## PRODUCT UPDATE

Number: #132  
By: Applications Engineering Dept.  
Date: May 28, 2014

### 3S Collet Slot Modification

**FFA.3S.742.CN**

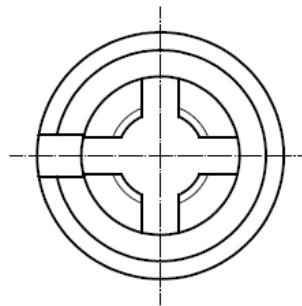
The design for ALL 3S C-Type Collets have been updated to have 4 slots rather than 6. The bevel shape surrounding the notch will also be slightly different. The collet part number will change to have a "T" suffix. The part numbers affected with this change are: FFA.3S.7\_\_.CN Below is an example of the new updated collet vs. the older version:
